Meeting	Planning Committee
Date and Time	Monday, 20th September, 2021 at 2.00 pm.
Venue	Walton Suite, Guildhall, Winchester

Update Sheet

Item No	Ref No	Address	Recommendation
	21/01727/FUL	Coventry House, Barfield Close, Winchester	Permit

Image 1: Extracted from Stroma's report: North West Corner of the building.

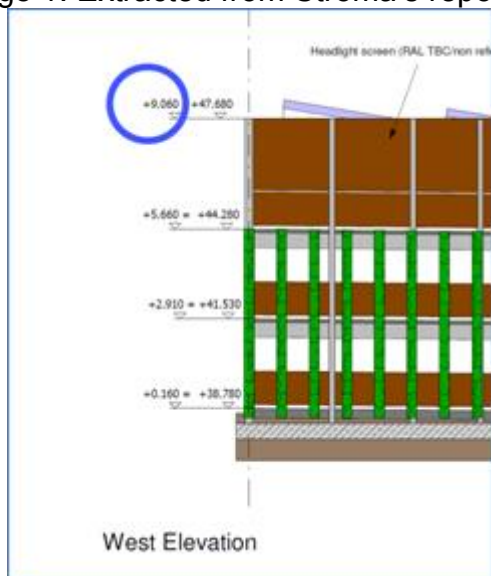
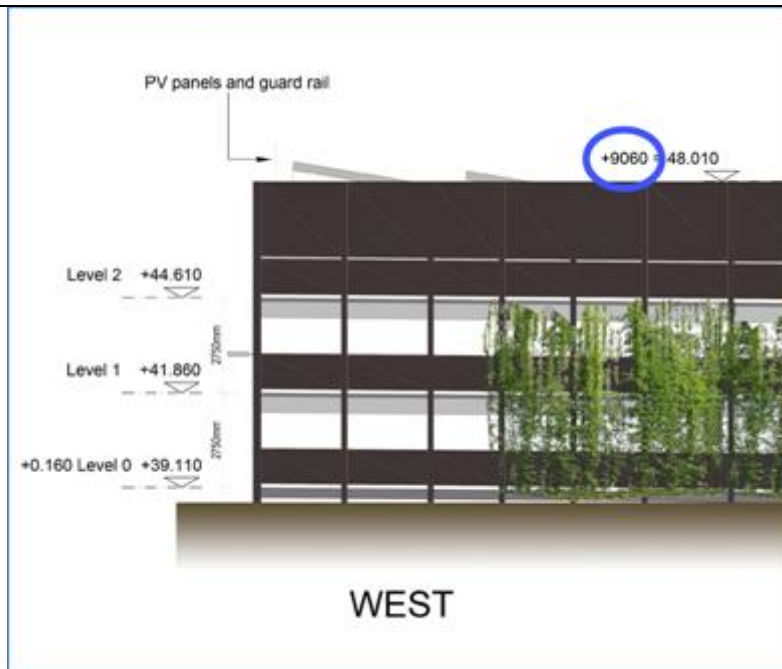
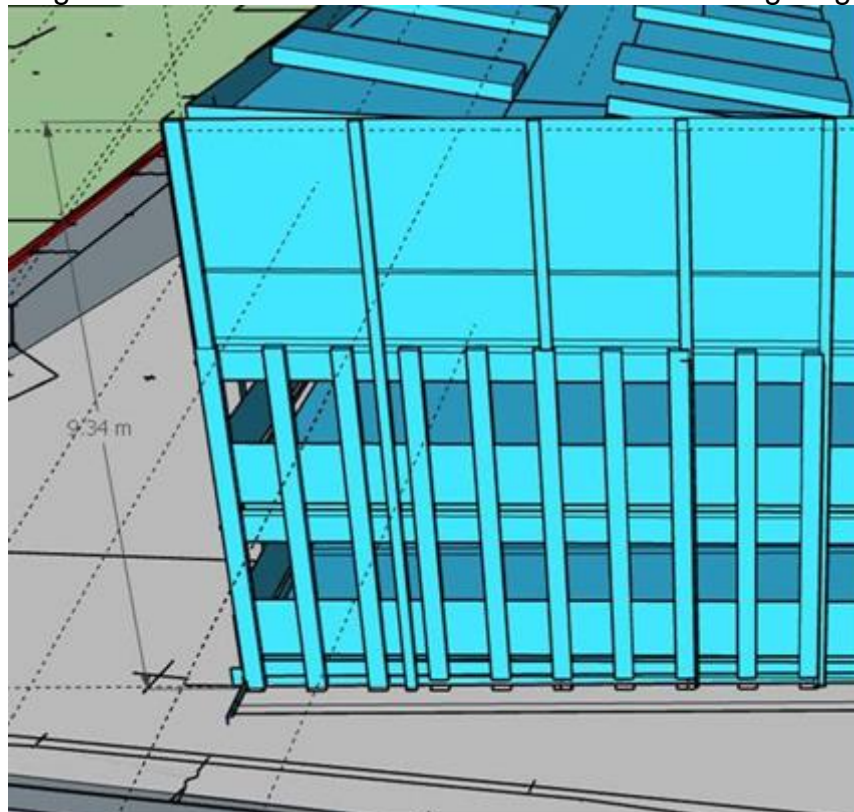
The Daylight and Sunlight calculations have been taken from incorrect drawings which are not the application scheme drawings. Appendix D of the assessment contains the drawings used. These show on the west elevation a height at the top of the level 2.5 screen and west stair core of 48.495 m AOD. The relevant

application drawing is VTX-STL-X-ZZ-DR-A-XXXX-0201 Revision PL01. That shows this staircase and screen at 48.825 m AOD. The level 2 screen is similarly higher in the application drawing: 48.010 m AOD compared to 47.680 m AOD in the Daylight and Sunlight Assessment.

The drawings referenced in the daylight/ sunlight report were used by Stroma to construct the building in the model and therefore the AOD values were not taken into account. The drawing Stroma used was produced during the first application. In short they used an outdated drawing with the wrong AOD values but the correct building size. The model therefore does not use or rely on the AOD values for the proposed building. The model itself is a relative representation of the site, including Domum road. Survey data was used to build a 3D model of the area to produce the level differences between the development and Domum Road. The scheme does not propose any substantial change in levels on the development site.

The drawing included in Stroma's report shows that the North West corner of the building is 9.060m from ground level (See image 1). Drawing number VTX-STL-X-ZZ-DR-A-XXXX-0201 Revision PL01 included as part of the application shows the same value (See image 2).

The model used in the Daylight/ Sunlight report is actually slightly bigger which has an effect greater than that of the proposed development. Instead of modelling a building that is 9.060m on this corner, they have in fact modelled it at 9.340m (See image 3). It is Stroma's standard practice to model the building slightly larger so that if there are any future changes or issues, the model and report does not need to be regenerated. It also compensates for construction tolerances so that the effect of the finished building will always be less than the modelled structure.
